OB-8

SCHEMATIC 1679A SHEET 2

OBERHEIM ELECTRONICS, INC.
ENGINEERING CHANGE ORDER

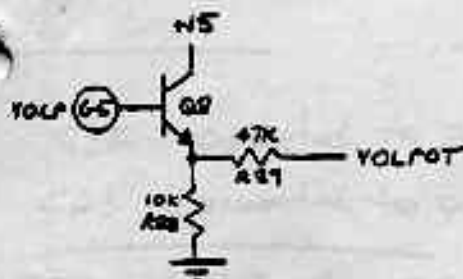
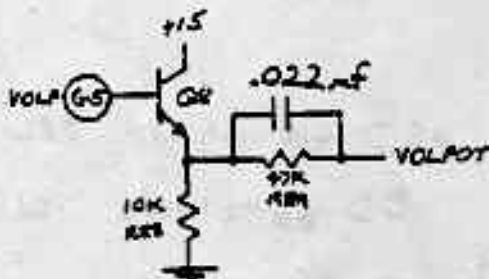
ADD .022 μ F CAPACITOR IN PARALLEL WITH R89.

TO ELIMINATE NOISE WHEN CONTROLLING THE VOLUME'S WITH AN EXTERNAL LOW IMPEDANCE VOLTAGE SOURCE.

OB-8 POT. Board 1&2 1681A

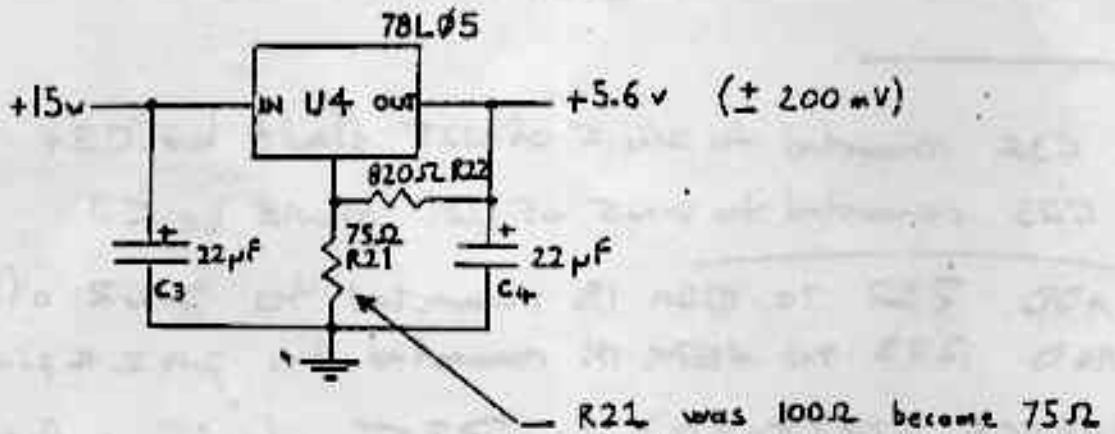
Reduce output of 5.6v Supply.

Increase the active range of the Front panel pots

OB-8 VOICE BOARD 1682A

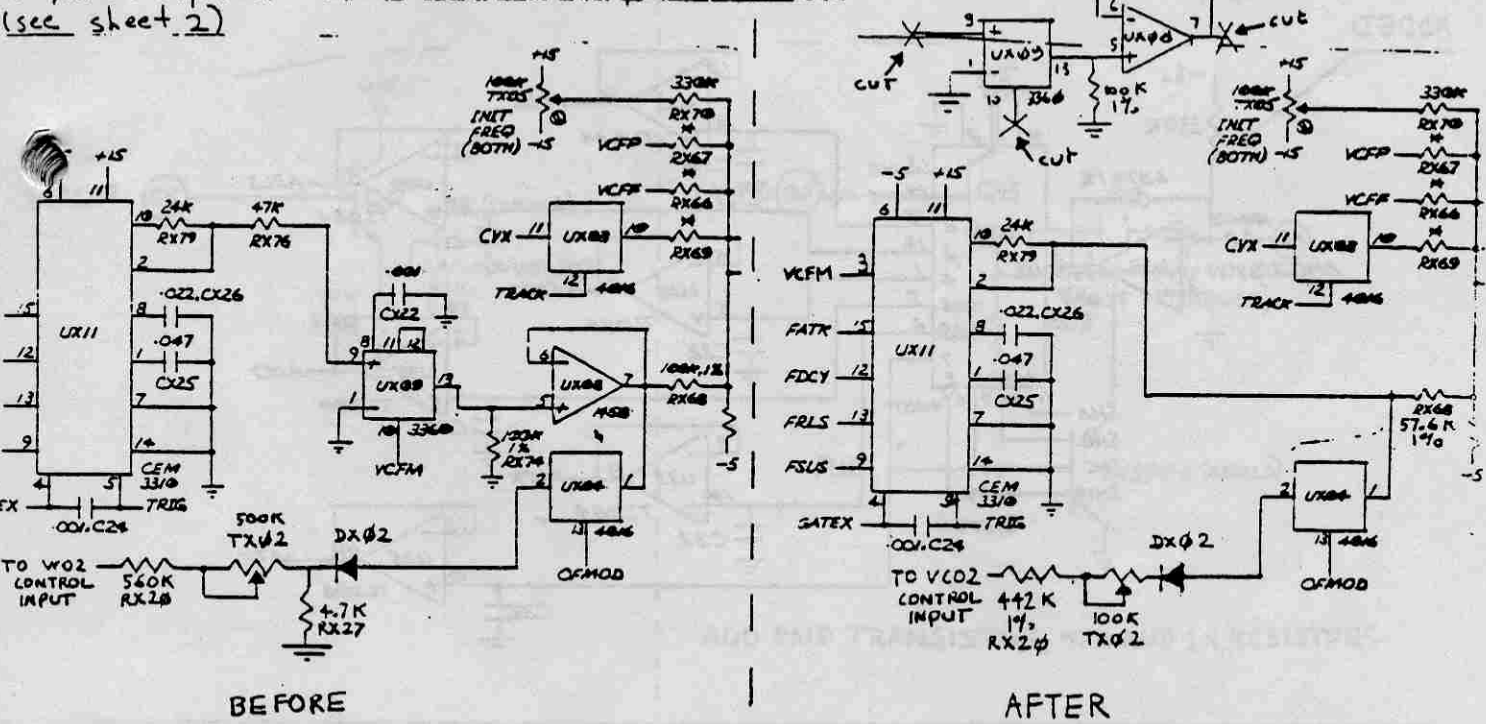
The 336 ϕ VCA is bypassed and the 331 ϕ in conjunction with the software modulates the amplitude of the envelope. A software revision A-4 or posterior must be installed.

331, at the output of U27 is short circuited. ϕ R30 is removed (see sheet 2)

Improve temperature stability and tracking of VCO2 filter env. modulation

OB-8 VOKE BOARD 1682A

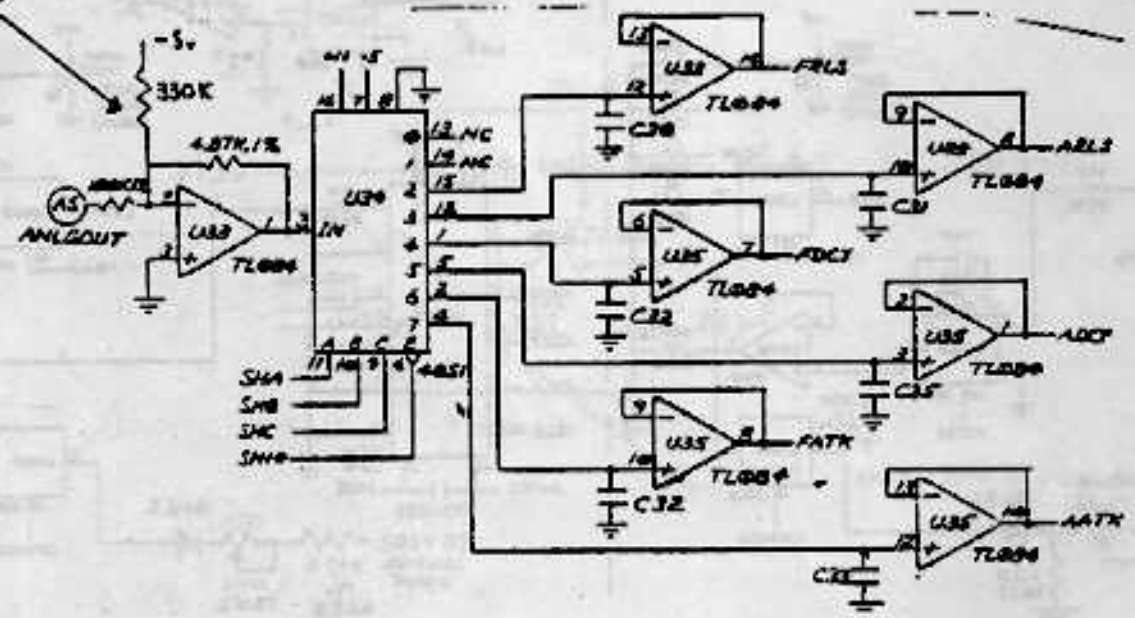
Add a resistor between -5v and pin 2 of U33 (upper & lower voice)
A software revision A-4 or posterior must be installed and the offset
calibration of the service center test must be performed.

The offset calibration routine of the service center test can correct
the TL084 for positive or negative offset.

SCHEMATIC 1679 A, SHEET 2
OB-8 PROCESSOR BOARD

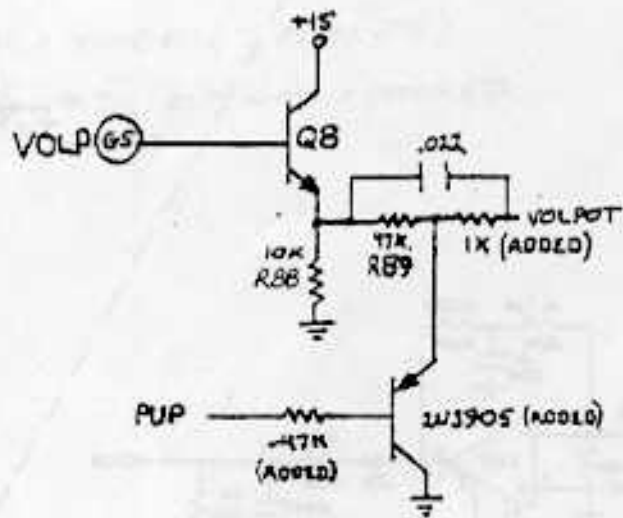
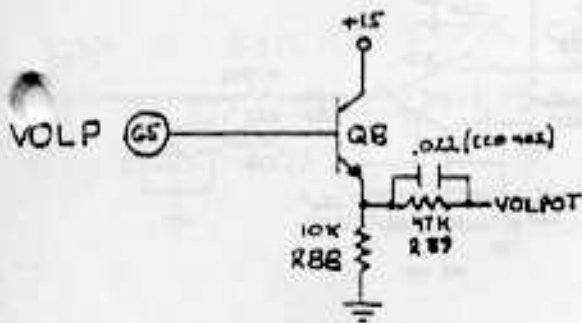
ADD PNP TRANSISTOR, 47K AND 1K RESISTORS

TO REDUCE POWER-DOWN GLITCH AT OUTPUTS

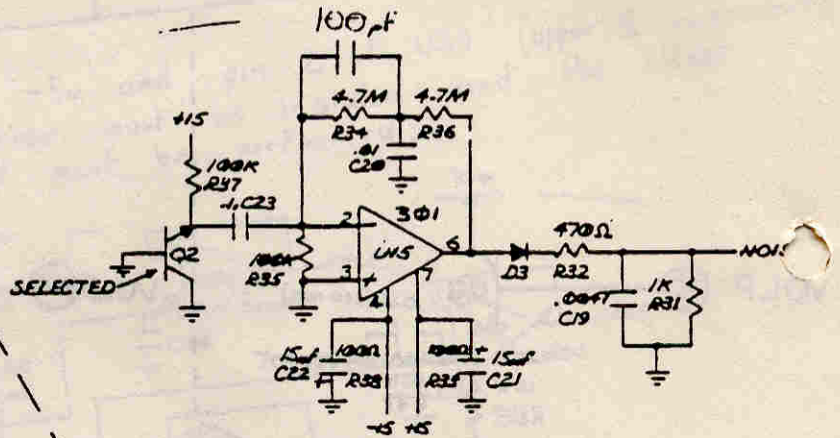
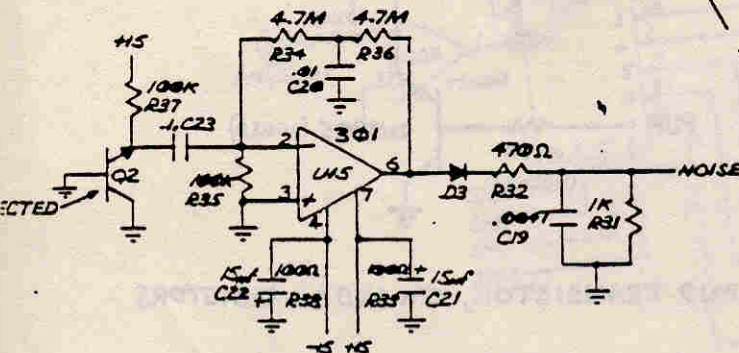
ADD A 100pF CAPACITOR
IN PARALLEL WITH R34

ON REVISION A PROCESSOR BOARDS, WHEN A SEQUENCER IS CONNECTED,
DISTORTION BECOMES PRESENT IN THE NOISE GENERATOR.

OB-8 BEND BOX 1680A SHEET 1 OF 1

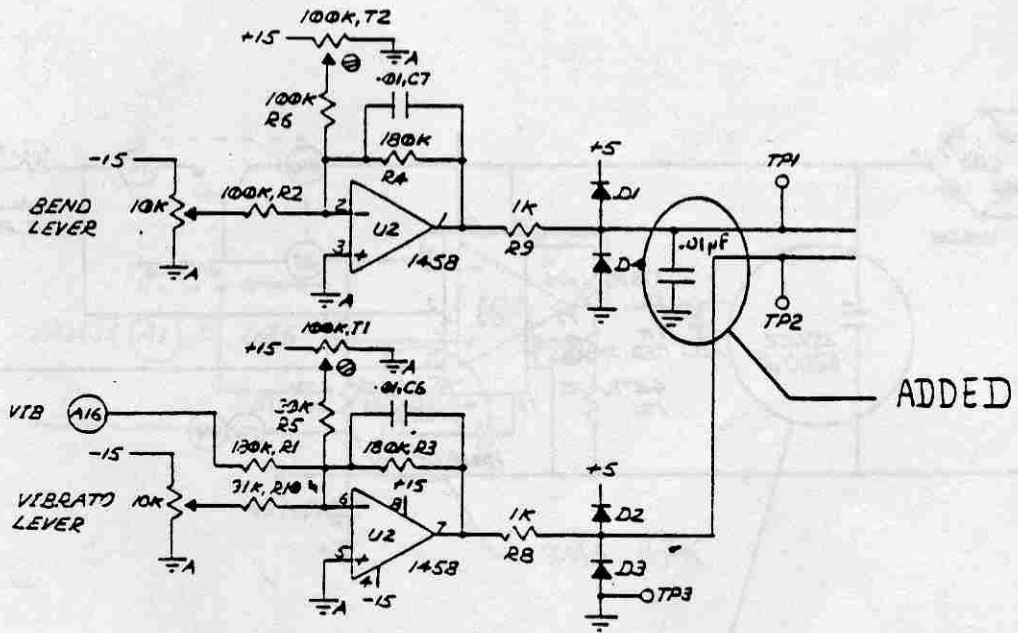
- REMOVES NOISE MODULATION FROM BENDER LEVER

PROCESSOR BOARD- POWER SUPPLY
1679A SHEET 4 of 4

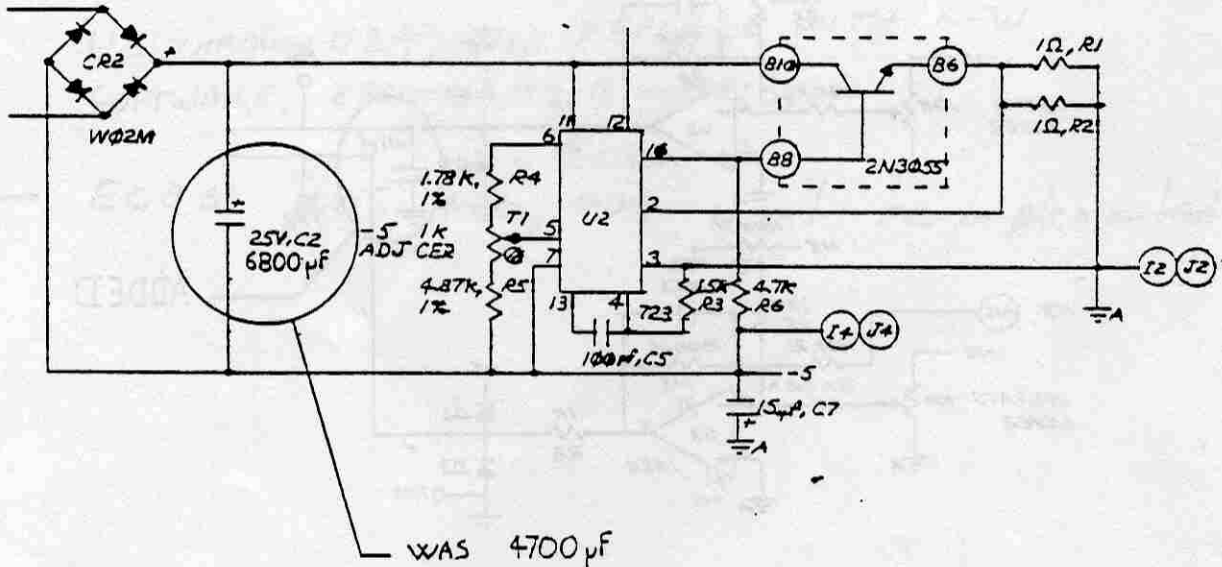
(REFERENCE ECO # 401)

WHEN THE NEW POWER SUPPLY TRANSFORMER (REF. 561021) IS USED, THIS CHANGE DECREASES THE OUTPUT THUMP ON POWER OFF.

DRAWINGS AFFECTED
VOICE BOARD 1682A SHEET 2 OF 3

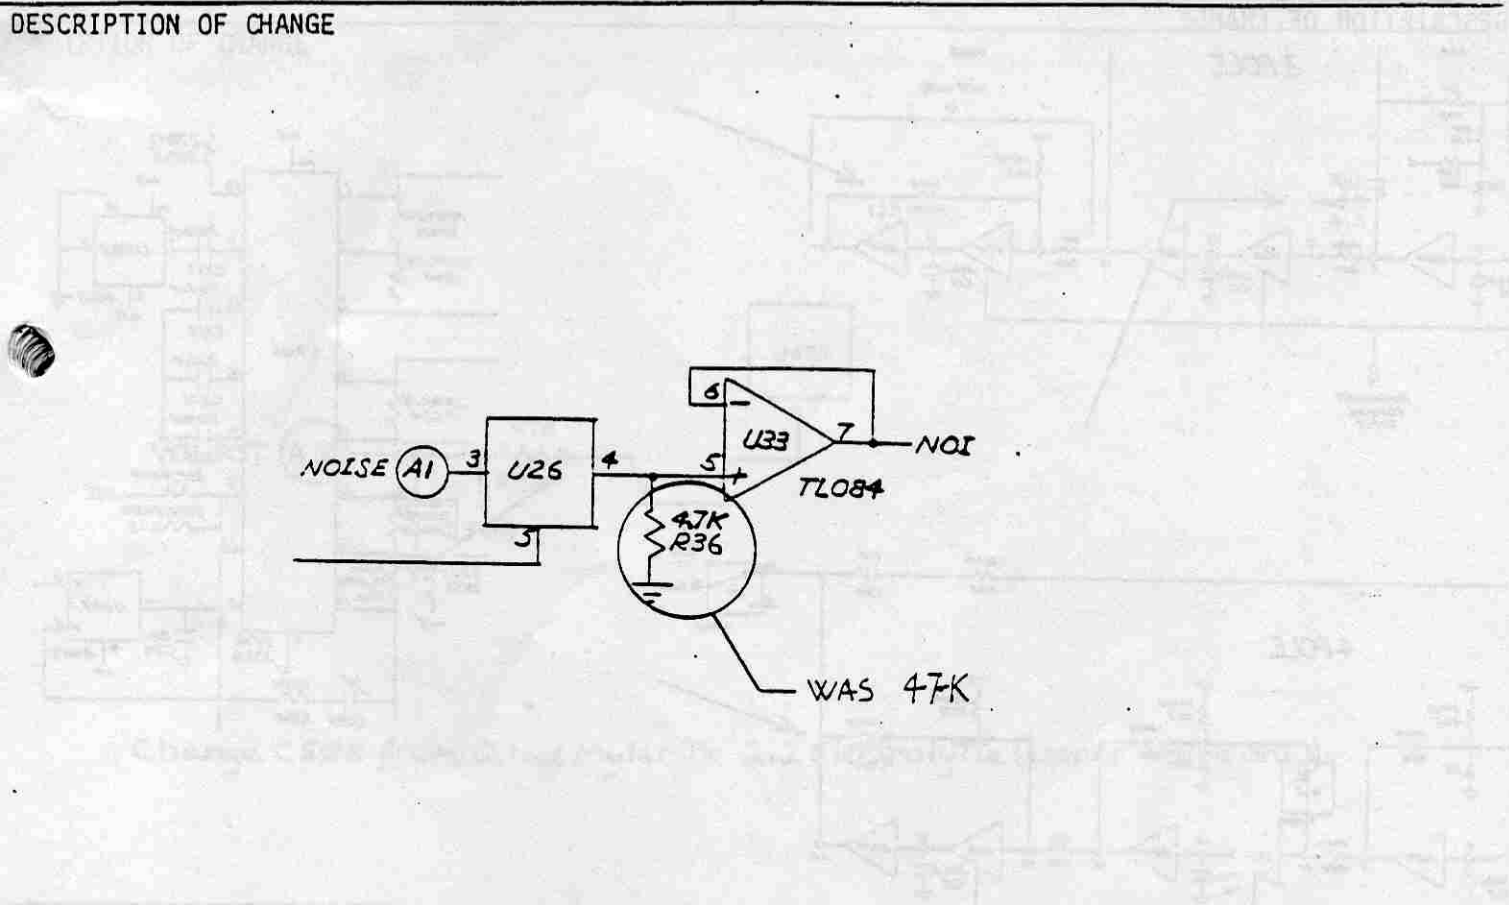
REASON FOR CHANGE
REMOVE LEAK OF NOISE GENERATOR WHEN A VOICE IS GATED

2 POLE/4 POLE CONFIGURATION

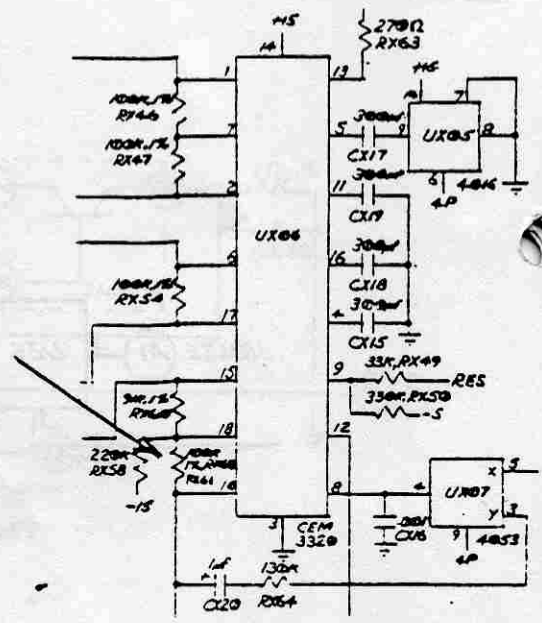
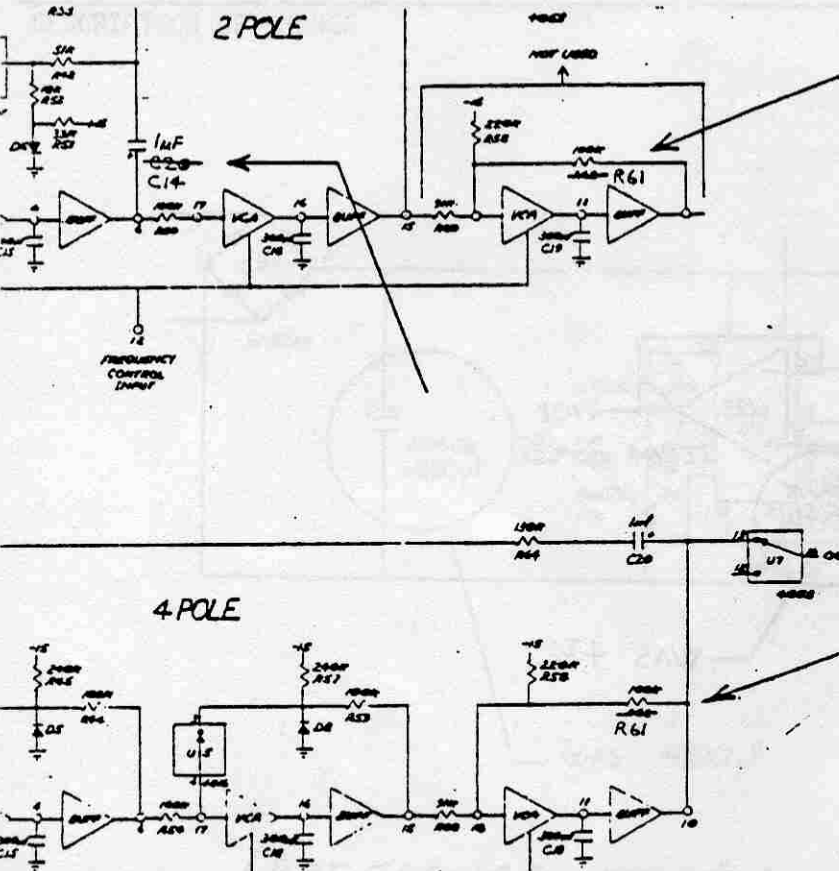
RESISTOR AT UX06 PINS 10, 18 MARKED RX68 SHOULD BE RX61.
 CAPACITOR IN 2 POLE/4 POLE CONFIGURATION DRAWING MARKED C20 SHOULD BE C14.

1682 B OB-8 VOICE BOARD (UPPER)

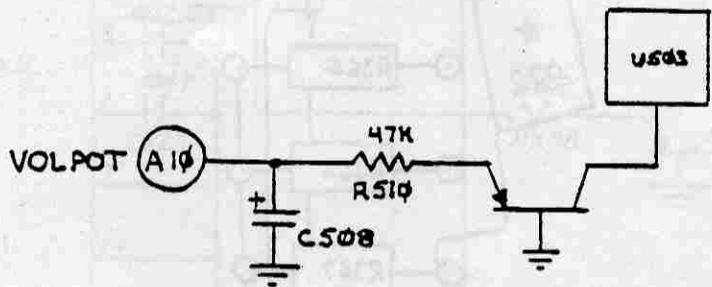
Change C508 from 0.1uf Mylar To 2.2 Electrolytic (Upper Voice only)

To eliminate noise at output at low master volume levels

1632 B OB-8 Voice Board
1639 B

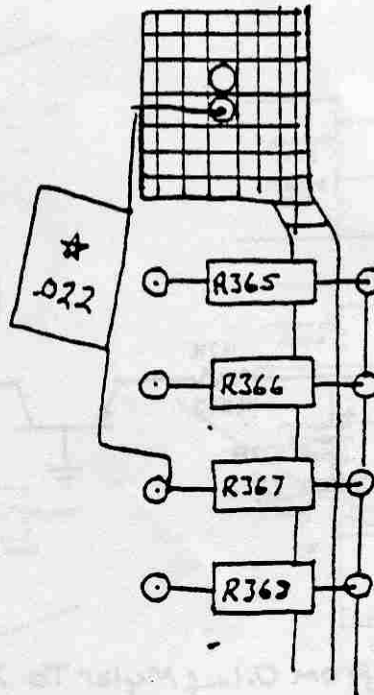
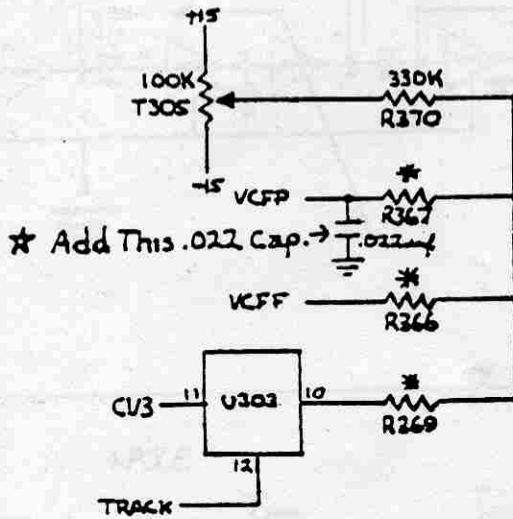
Add a .022 Mylar Capacitor To both The Top and bottom Voice Boards

To Filter-out digital noise picked up along The Filter Pedal line (VCFF) when a Sequencer (05X) is connected.

OB-8 VOICE BOARD 16.82 B SHEET 3 OF 3

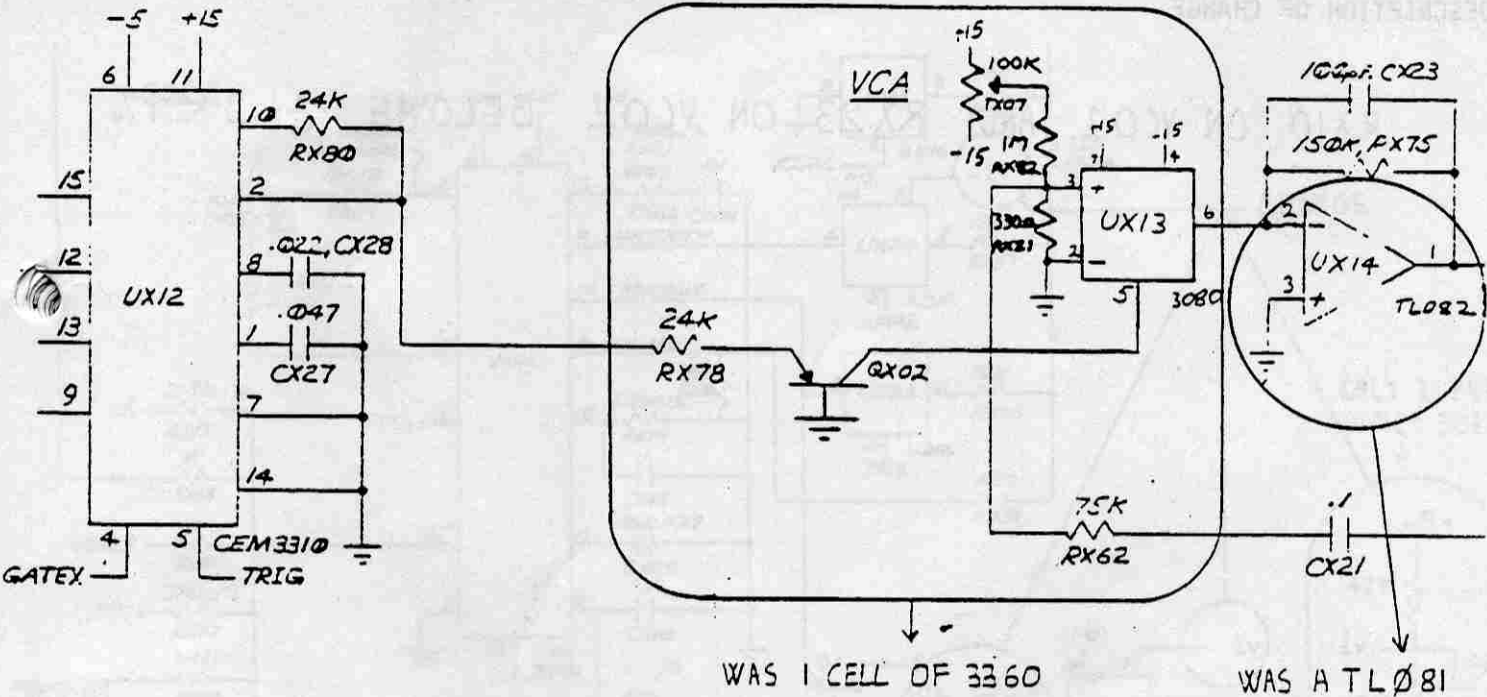
- ALSO: UX08 IS DELETED AND REPLACED BY THE OTHER CELL OF THE TL082 UX14

- RATIONALIZE THE CIRCUITRY

OB-8 VOICE BOARD 1682A SHEET 3 OF 3

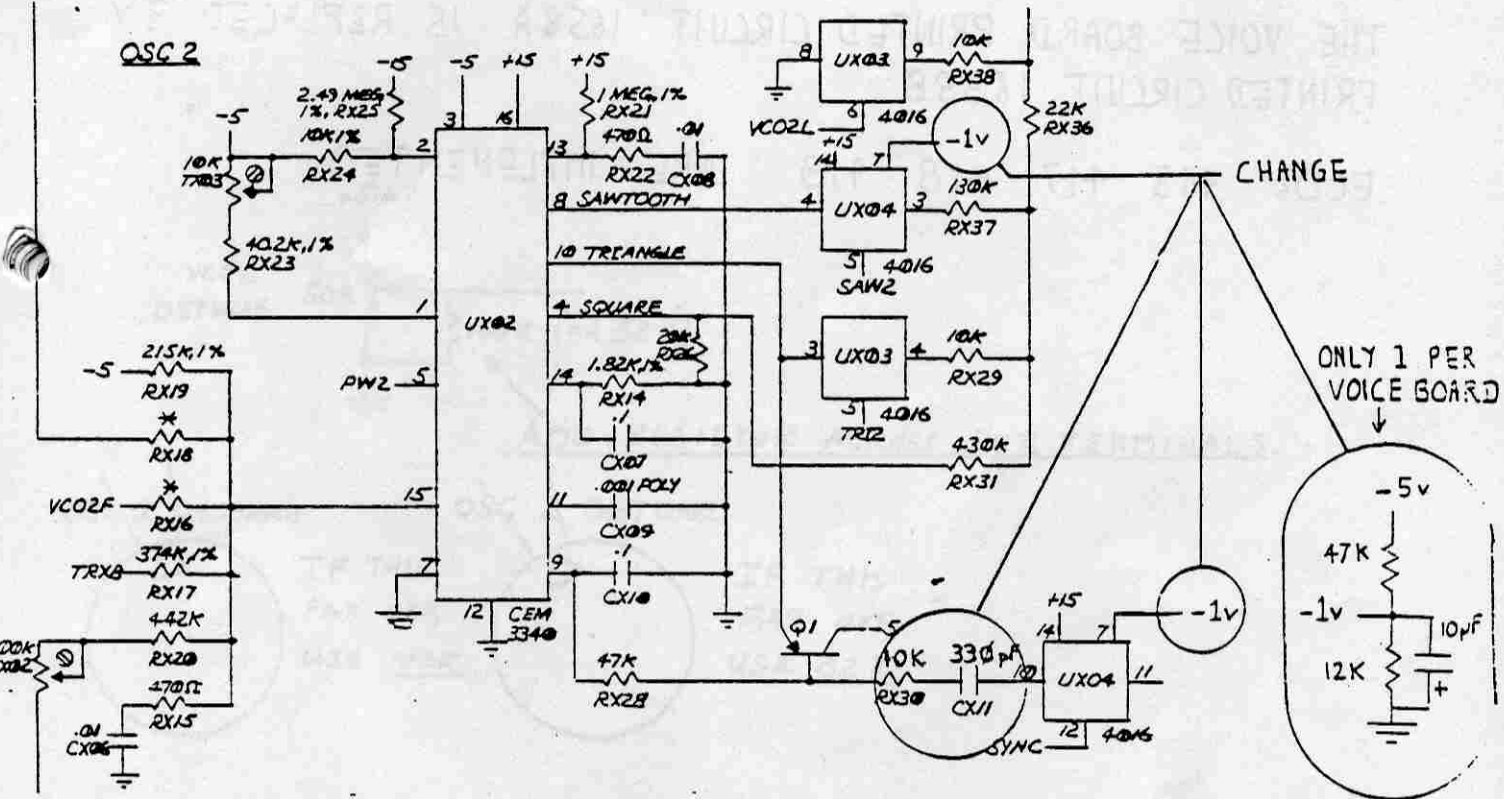
- IMPROVES SYNCHRO SOUND

POT BOARD 1681 B

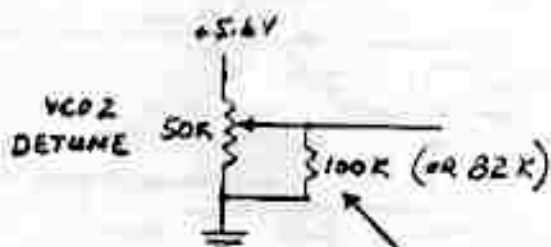
ADD RESISTOR ACROSS POT. TERMINALS.

IF THIS
FAR OFF,
USE 100K

IF THIS
FAR OFF,
USE 82K

TO CENTER OSC 2 DETUNE CONTROL WHEN LED GOES OFF
WITH KNOR SIGNIFICANTLY COUNTERCLOCKWISE OF CENTER.
